***Master Plan Amendment #2018-0007***

***CDD Concept Plan #2016-0003***

***Greenhill / West Alexandria CDD –***

***504 South Van Dorn Street; 5650, 5660, and 5730 Edsall Road;  
and 501 and 611 South Pickett Street***

Figure 1: Preliminary CDD Concept Plan

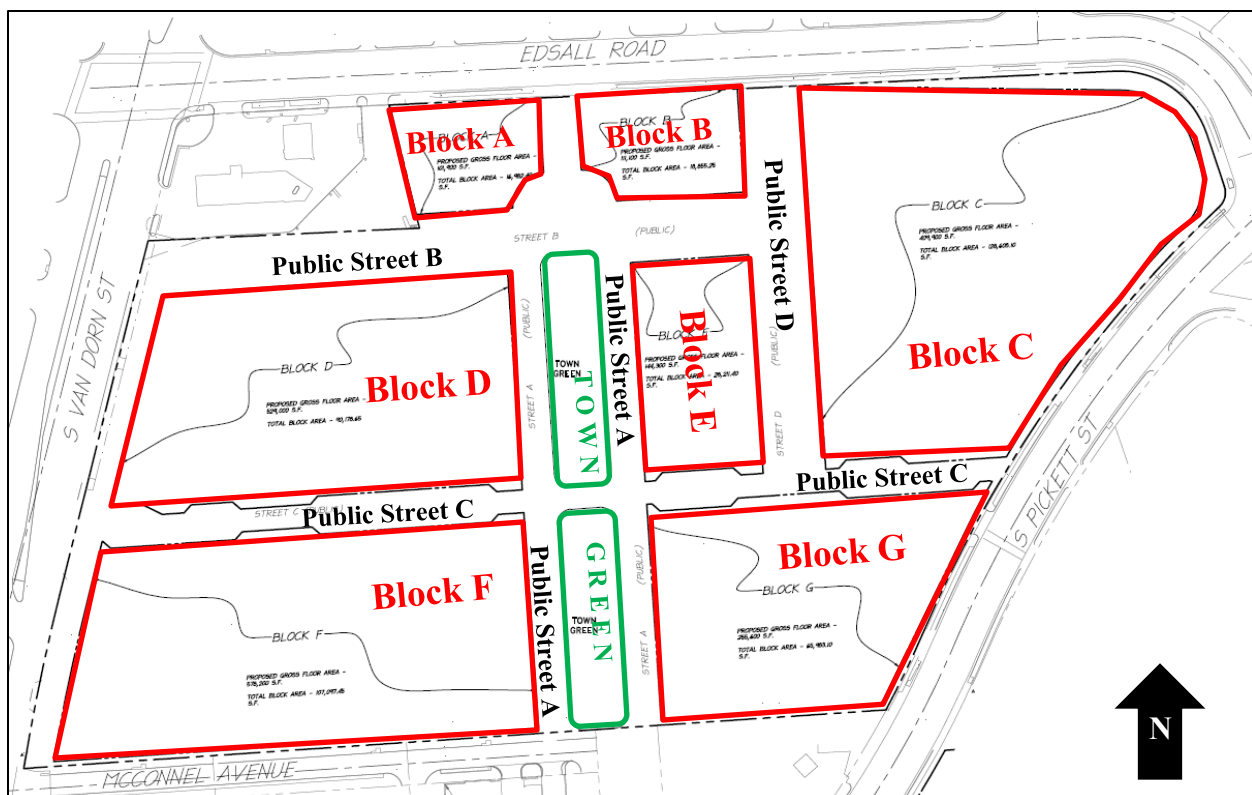
The requested an eastward shift of the major north-south street (Public Street A) by approximately 35 feet would better align its southern terminus with the potential northern terminus of the multimodal bridge. In the applicant's preliminary plan, Public Street A was located far enough to the west that any future connector road to the south would have difficulty clearing the northeastern corner of the Modera Tempo building. Although a connection from Public Street A to South Pickett Street and the potential multimodal bridge would involve the use of private property not included within the CDD Concept Plan area, staff nonetheless believes it is important to not preclude such a connection in the future. The Corridor Plan envisioned the street in question potentially connecting to South Pickett Street and the potential multimodal bridge landing in this location provided an additional rationale for such a request.

Staff requested that the applicant provide a full public right-of-way of 78 feet for Public Street C as recommended in the Corridor Plan rather than the originally-proposed 24 to 44-foot widths, which would have included only the distance between the street's northern curb to its southern curb. In the revised right-of-way for Public Street C, the majority of the streetscape would be located on public property as required for the majority of new development projects in the City. The applicant has agreed to both the realignment of Public Street A and the standard right-of-way width for Public Street C and has incorporated both changes into a new exhibit included as Graphic #2 in Section VIII of this report. Staff has included condition language (Conditions #14 and #16) to memorialize this agreement and to incorporate the changes into a revised CDD Concept Plan.

Exhibit A - Roadway Connection Not Preferred

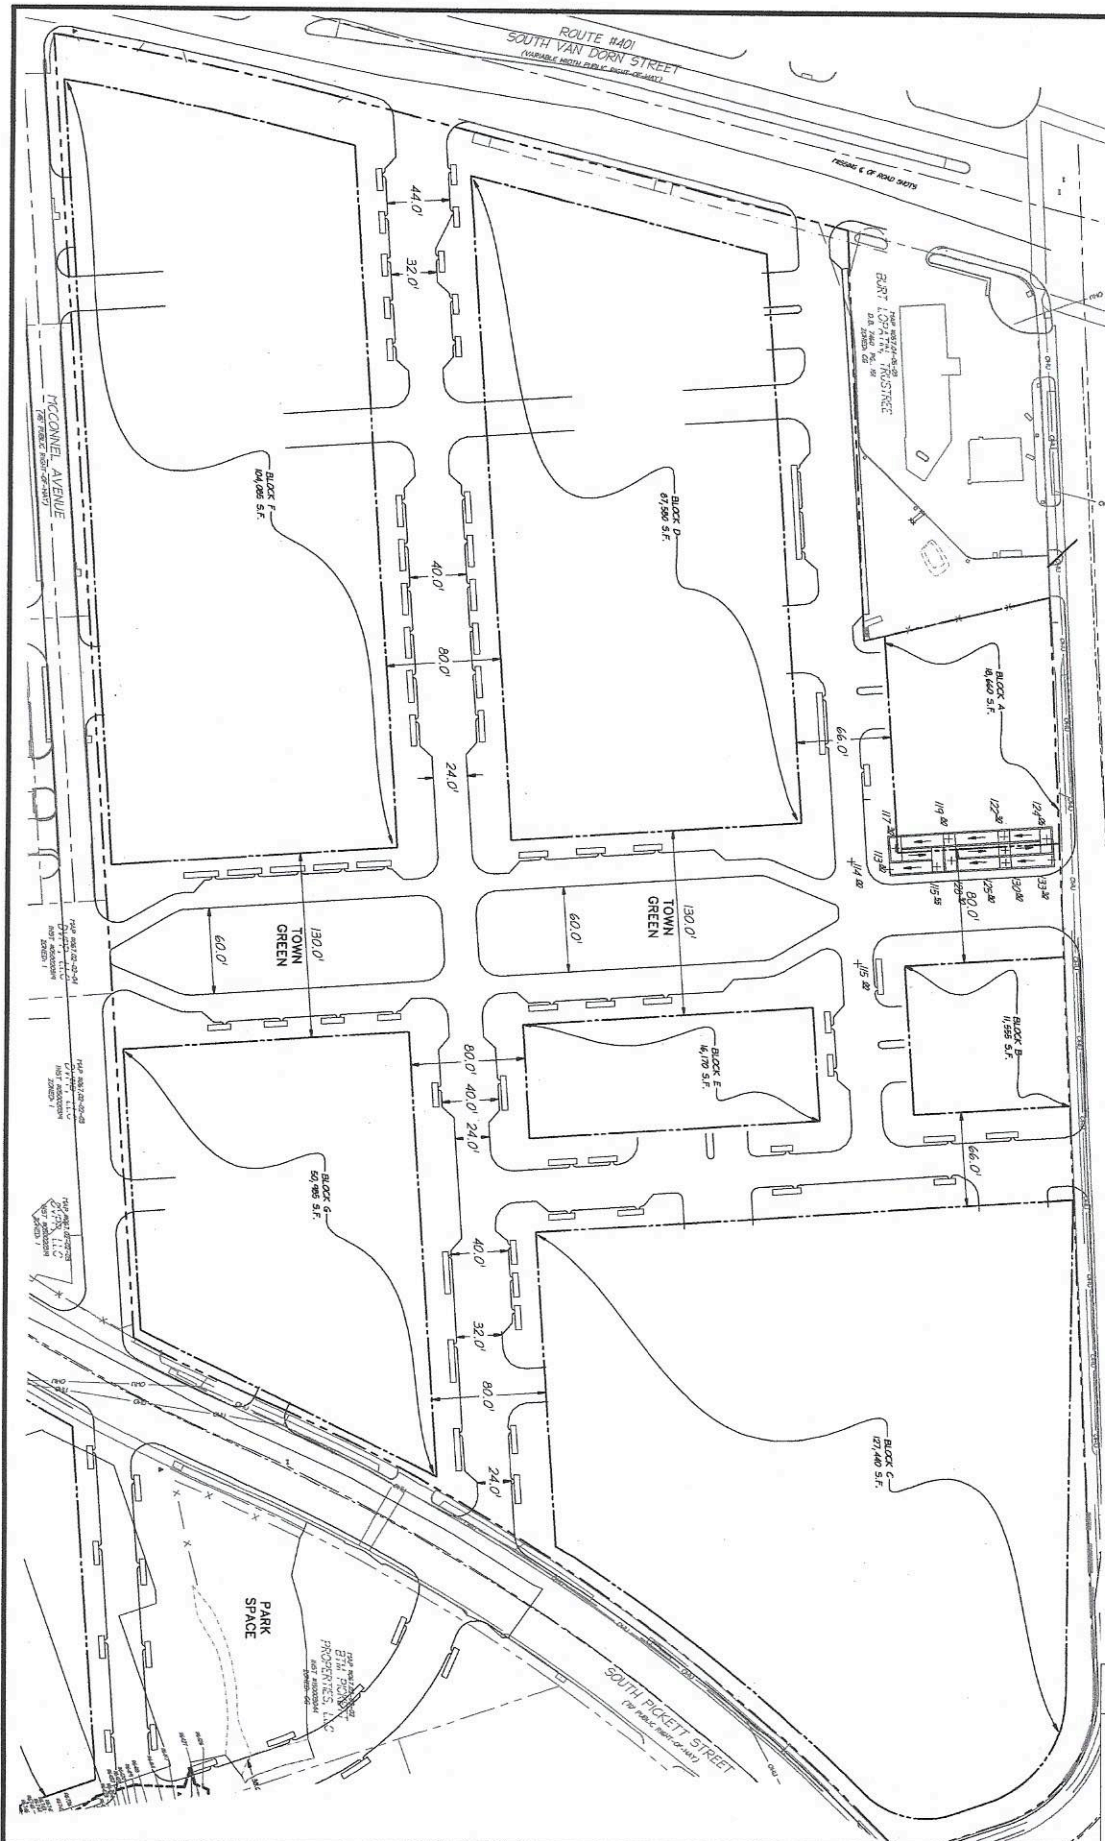
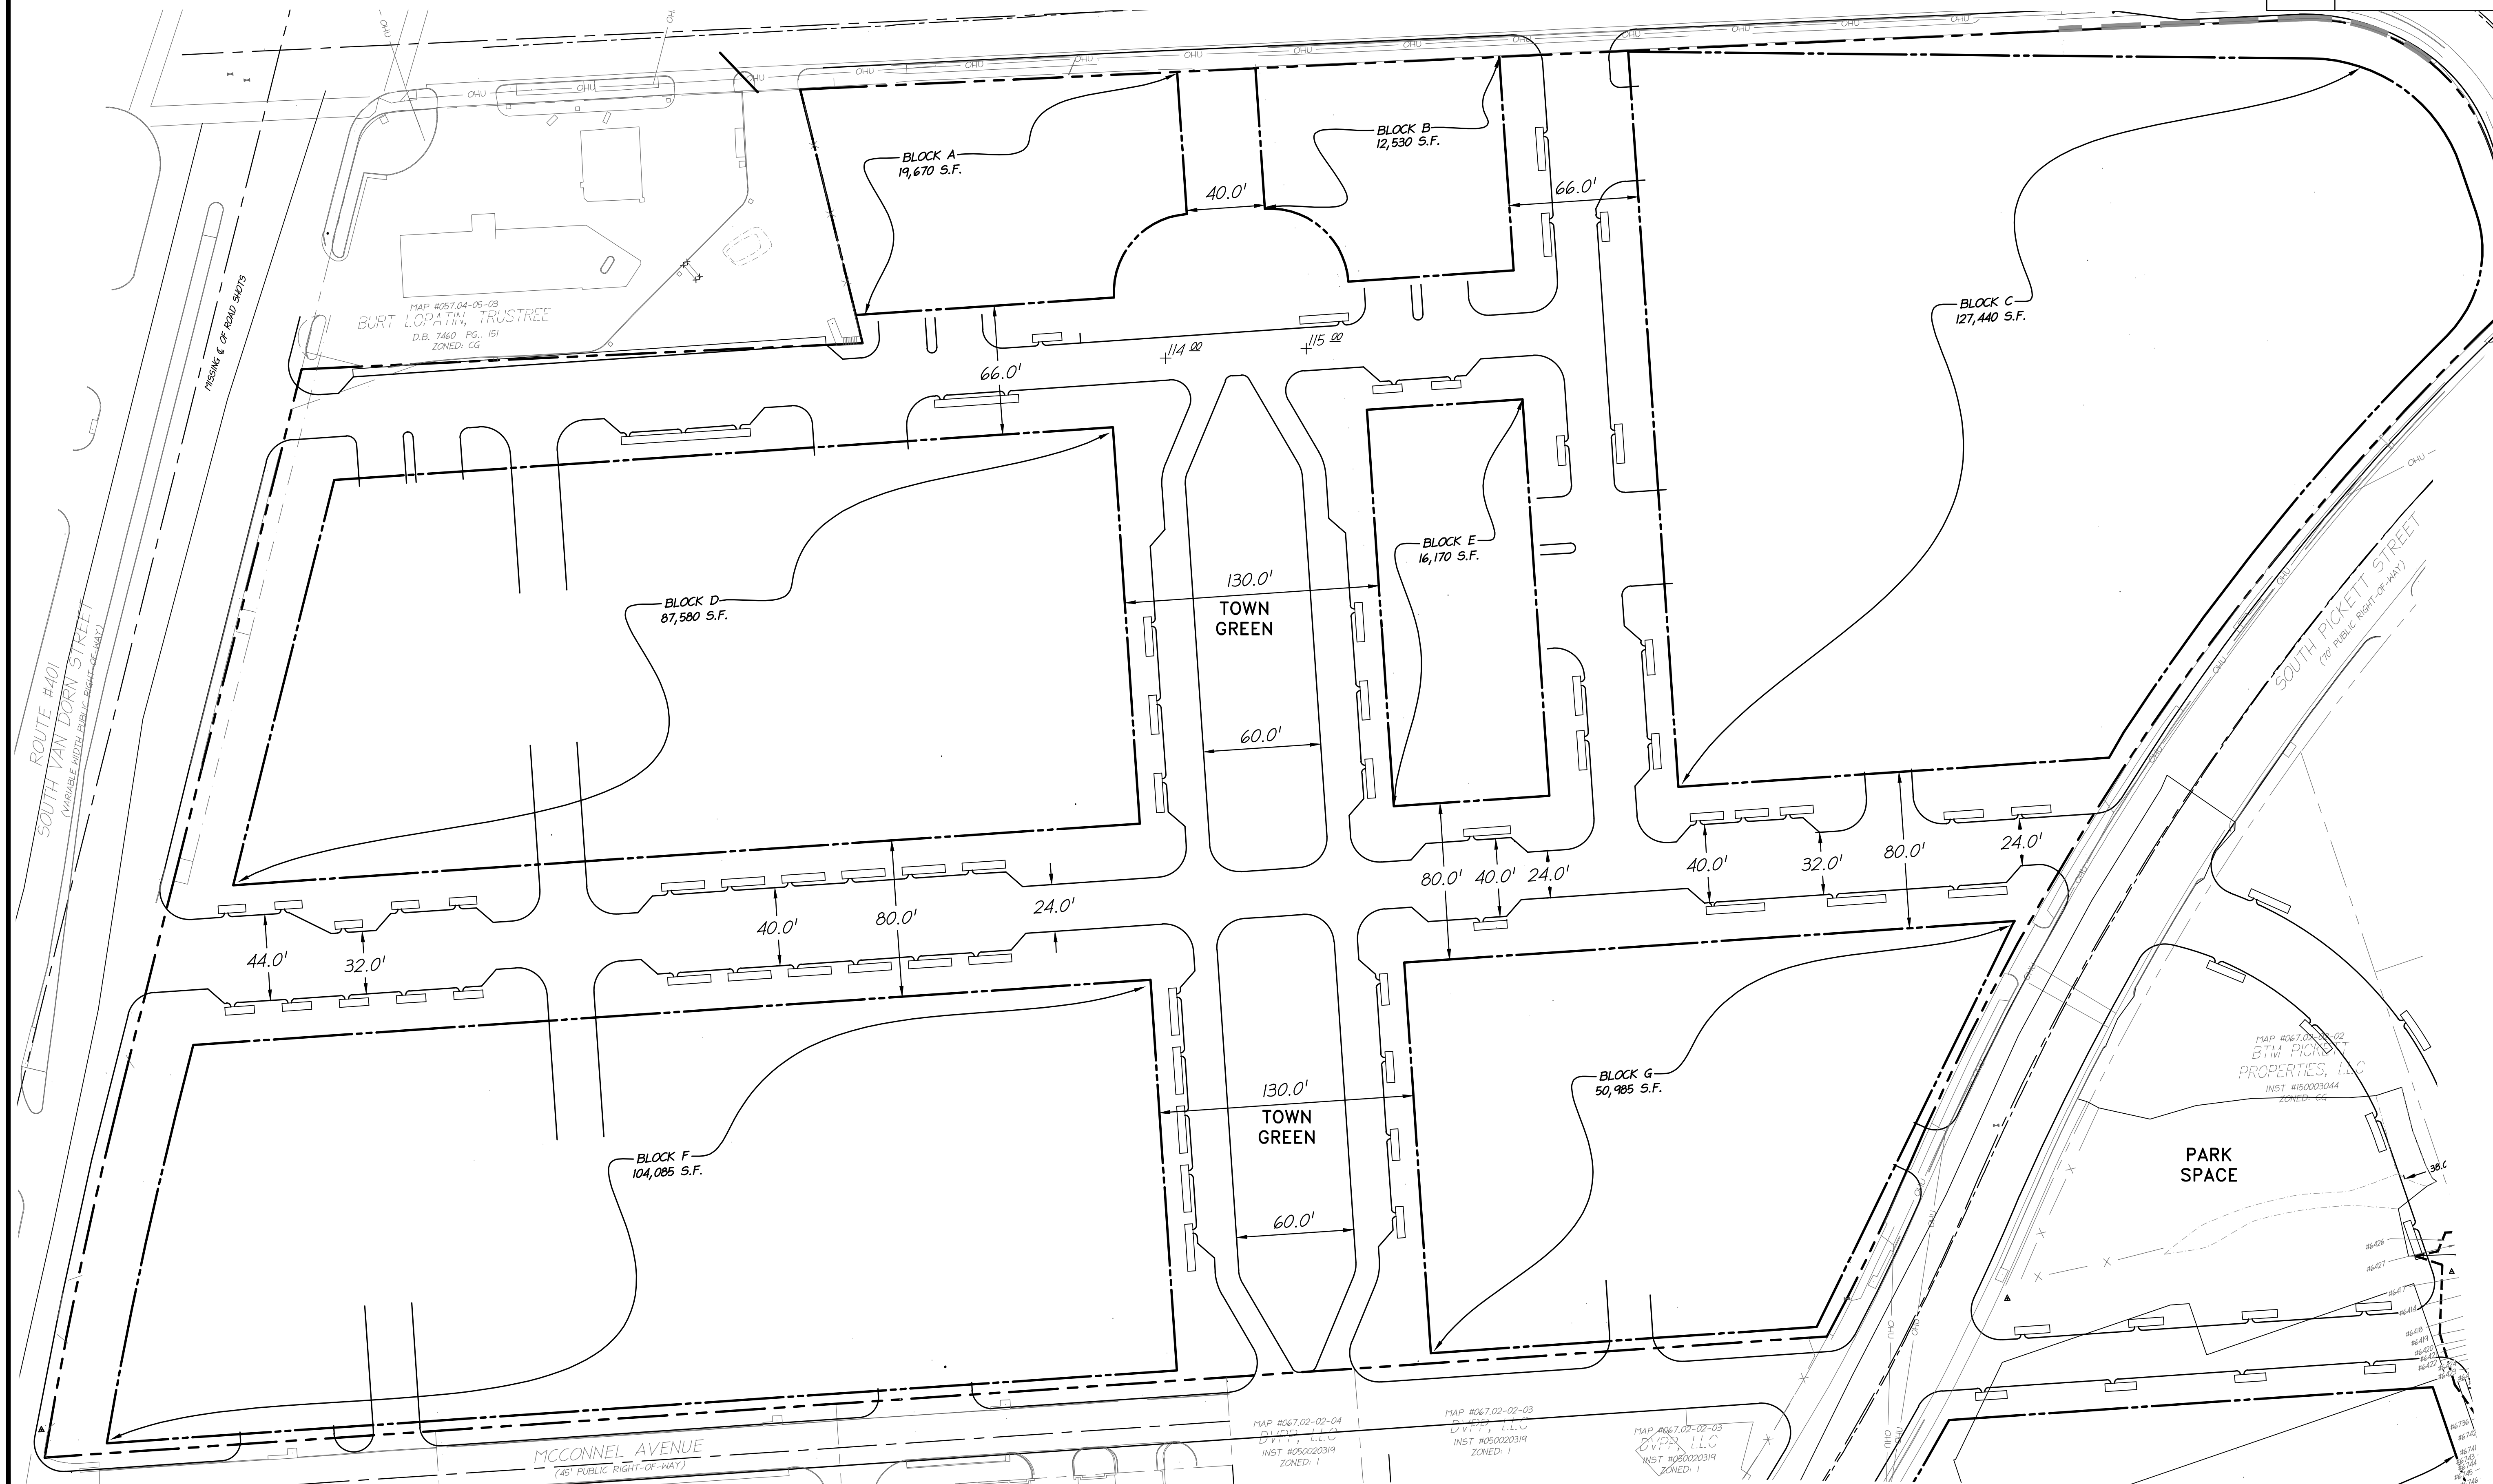
We continue to disagree that it is advisable from an engineering perspective to provide a vehicular connection to Edsall road via Public Street A (the major north-south street). As a result, we did not include the following change: "The reconfiguration of the area between Blocks A and B, now listed as the "Spanish Steps," to allow for a vehicular connection to Edsall Road. The right-of-way width to depict between Blocks A and B would be 80 feet." As you can see on Exhibit 1, attached hereto, we believe the vehicular connection is not advisable for several reasons. First and foremost, the change in grades between Edsall and the new Public Street "B" would cause the slope of that portion of the road to be at 14%, a slope not recommended on a regular basis by the Department of Transportation and Environmental Services. Vehicles coming up that 14% slope to the new intersection would be at a disadvantage moving into the

## City's Suggested Alternative

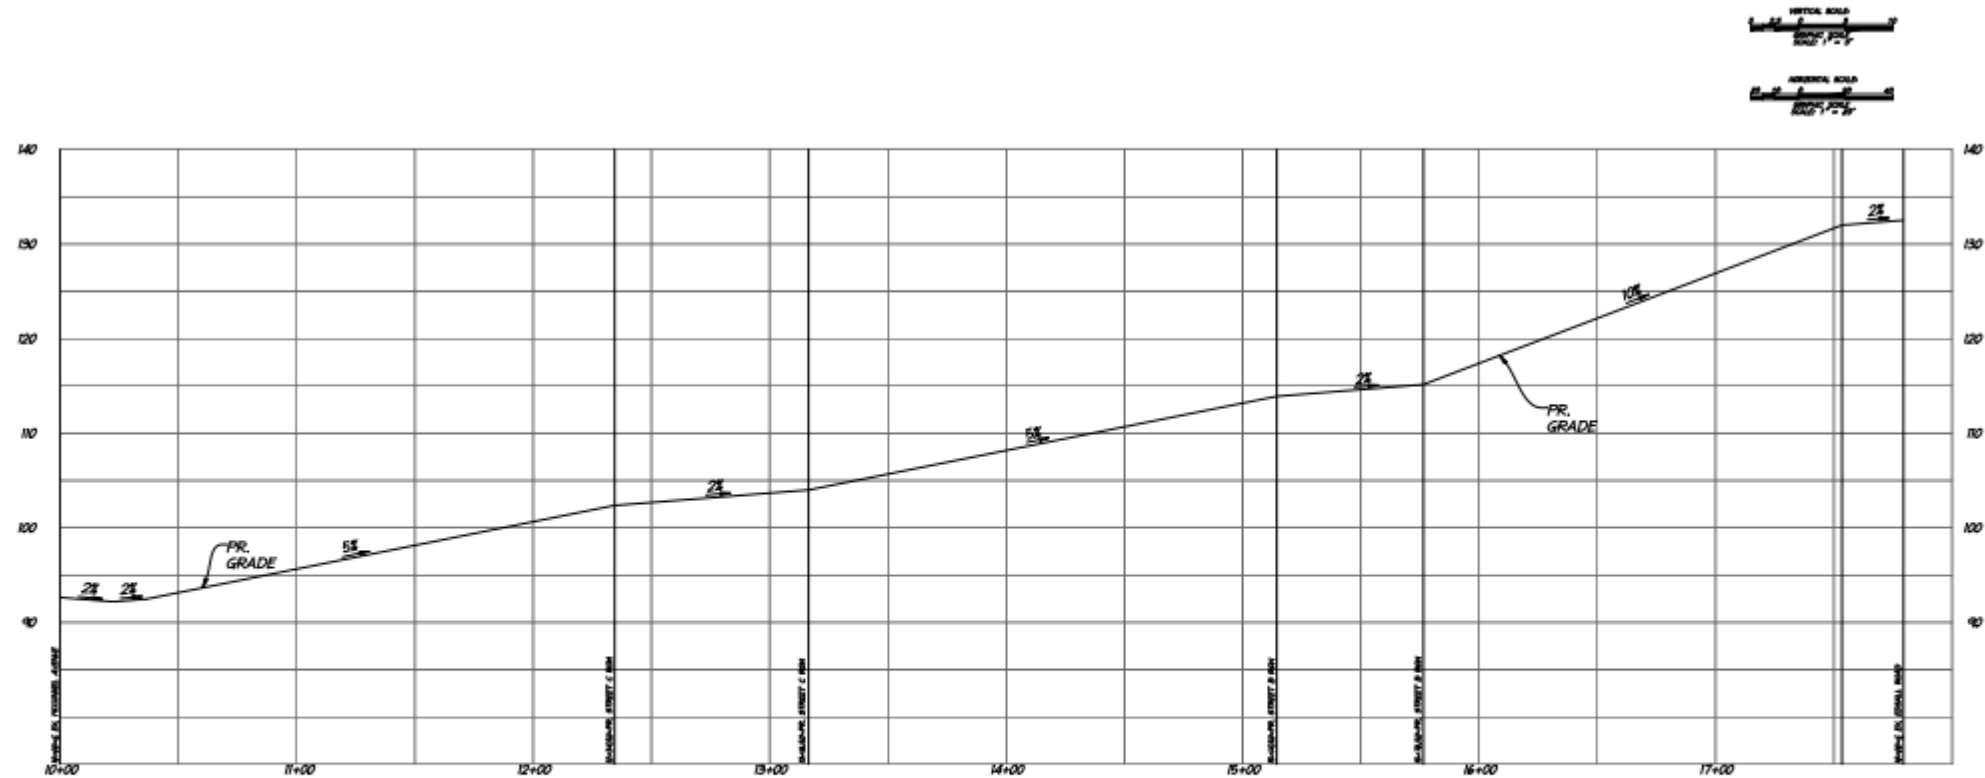
- Requires Grades in Excess of ADA Requirements for Sidewalks.
- Requires an 8-14% grade from Town Green up to Edsall, which would require switchbacks for pedestrians.
- Removes 15 feet from each building on Blocks A & B necessitating higher heights.
- Makes the street more of a Thru Street than a Local Street, negatively impacting the Town Green/Retail.
